CITY OF ALBUQUERQUE

**RE: U-Haul
2217 4TH St. NW
Temporary C.O. - Accepted
Engineer's Certification Date: 11/17/22
Engineer's Stamp Date: 04/20/20
Hydrology File: H14D110**

U-HAUL
4TH AND I-40

GRADING AND DRAINAGE PLAN

SHEET #
C-2

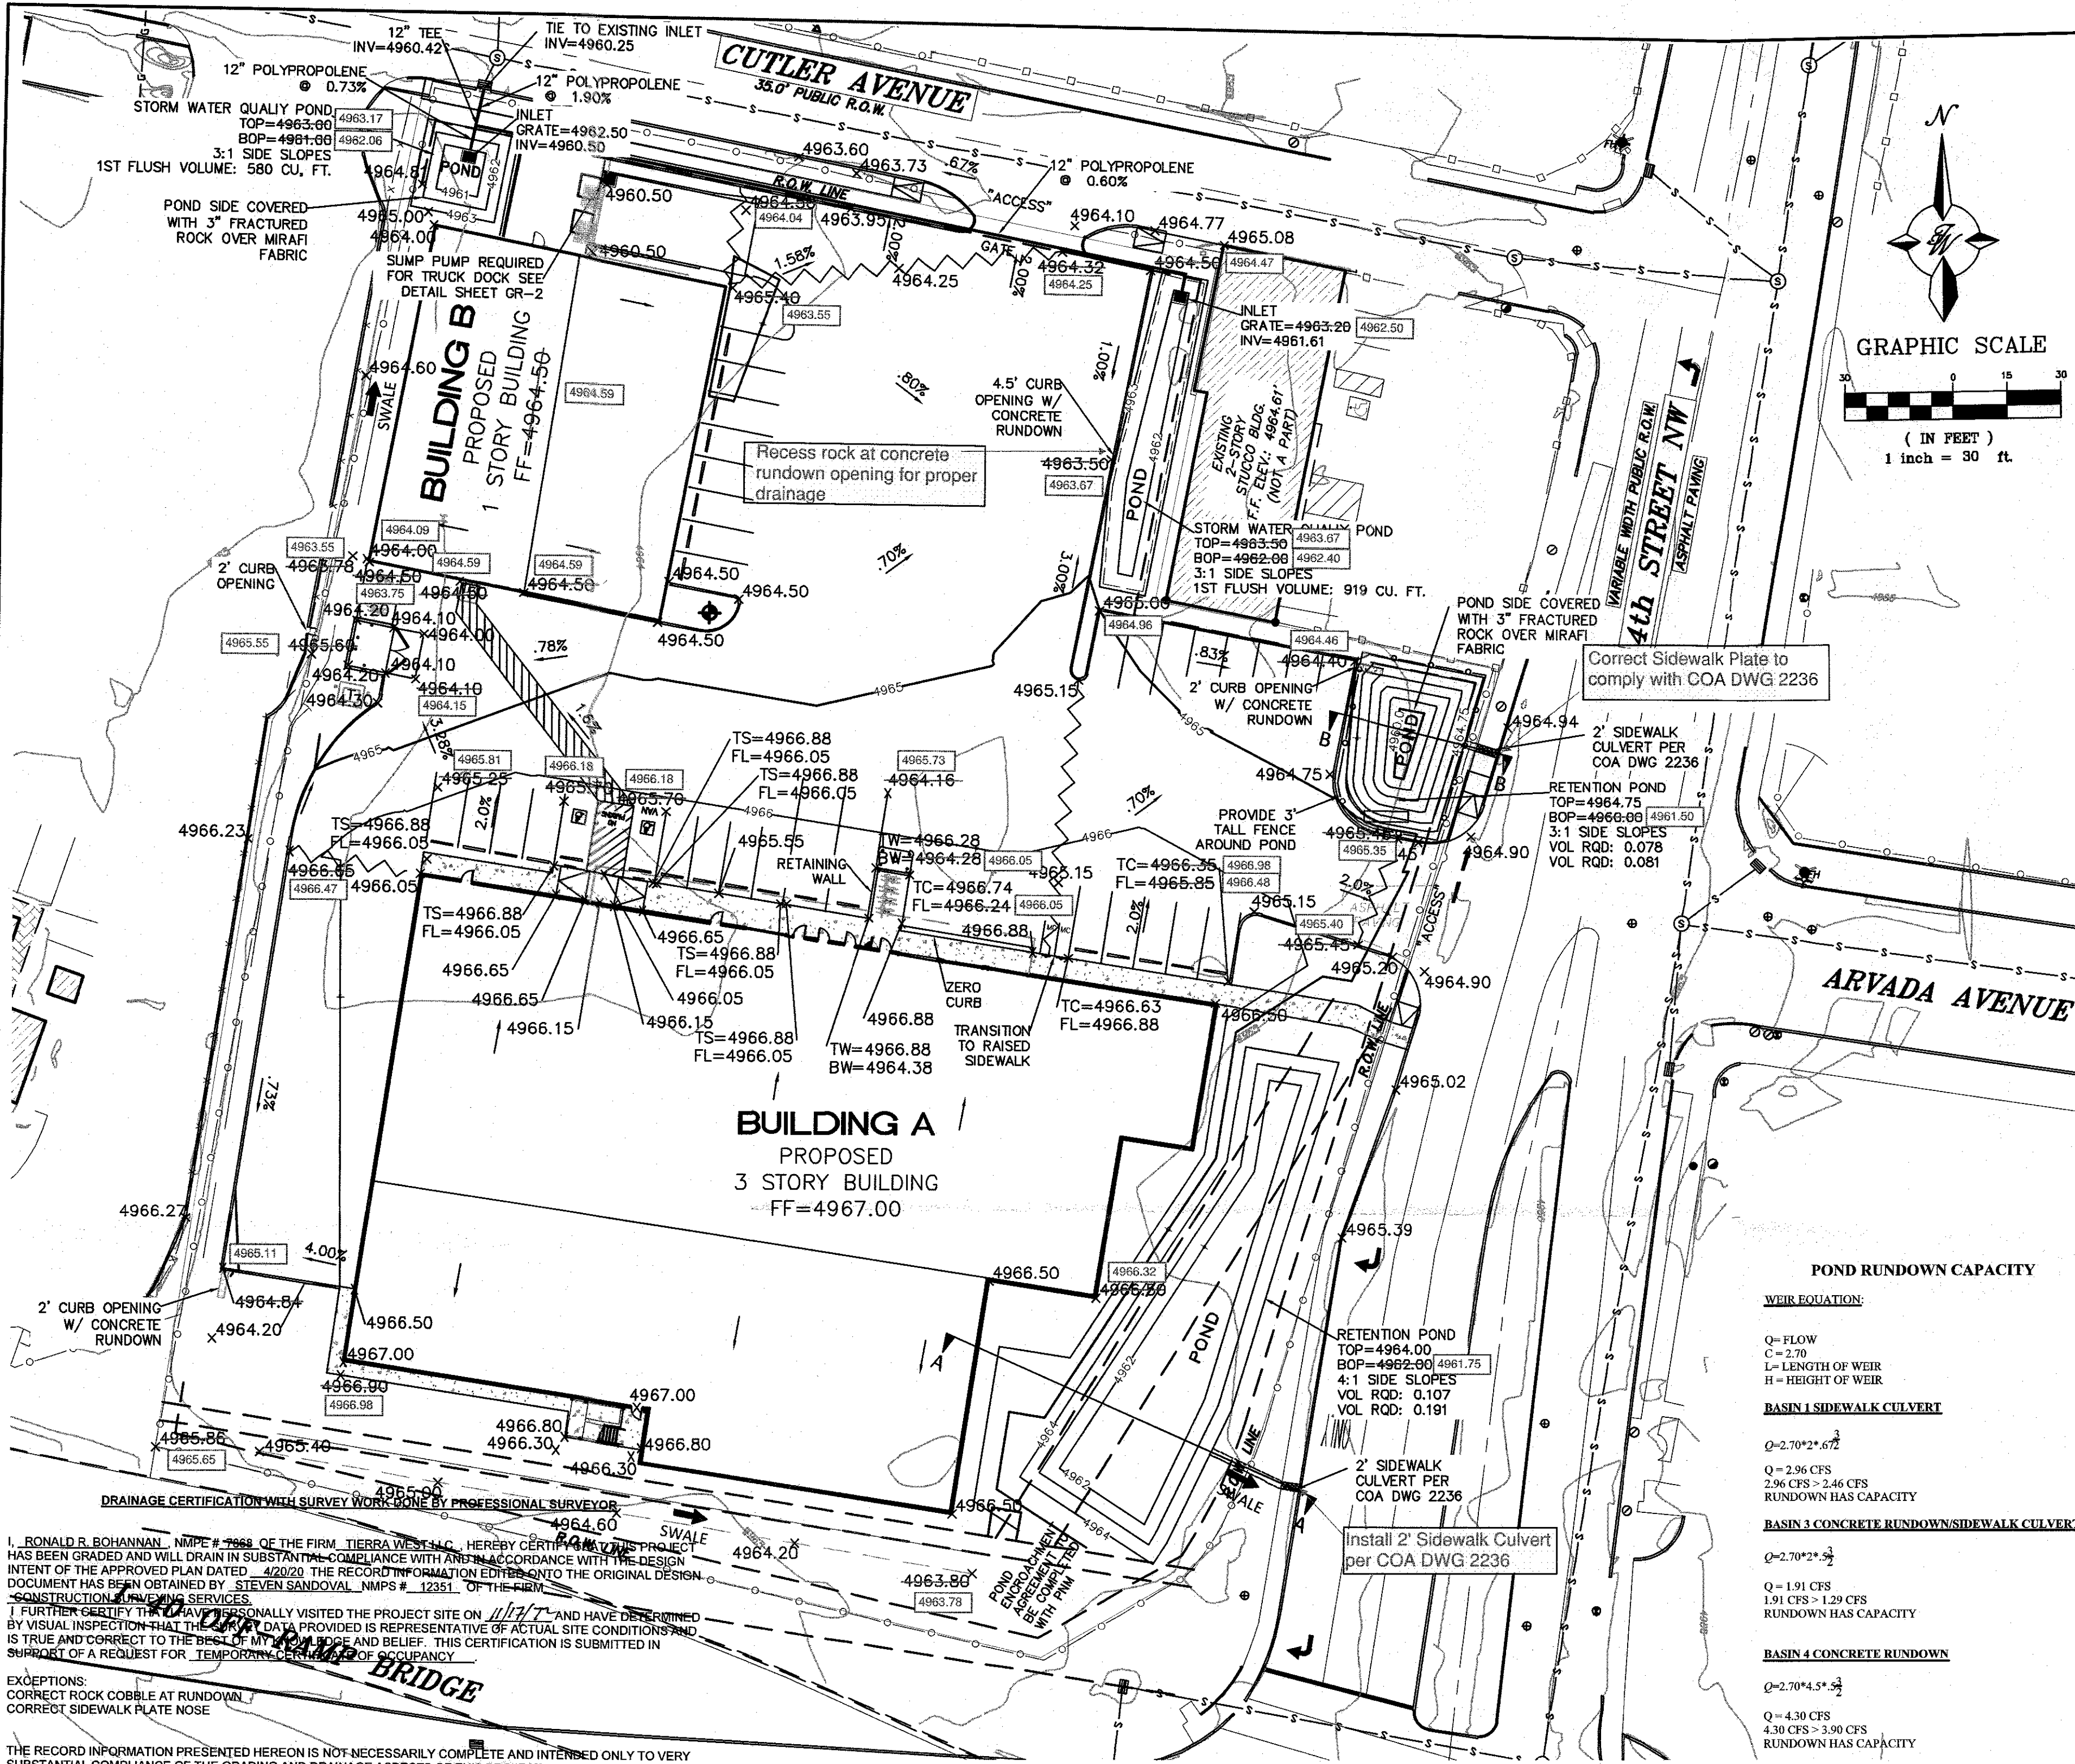
Based **solely** on the Certification received 11/18/2022, this certification is approved in support of Temporary Release of Occupancy by Hydrology.

1. Please resubmit application. Hydrology needs a site visit prior to approval.
2. Please provide the Drainage Covenant with Exhibit A for the stormwater quality ponds per Article 6-15(C) of the DPM. Please submit the original copies along with the \$ 25.00 recording fee check made payable to Bernalillo County to Carrie Compton (cacompton@cabq.gov) on the 4th floor of Plaza de Sol.
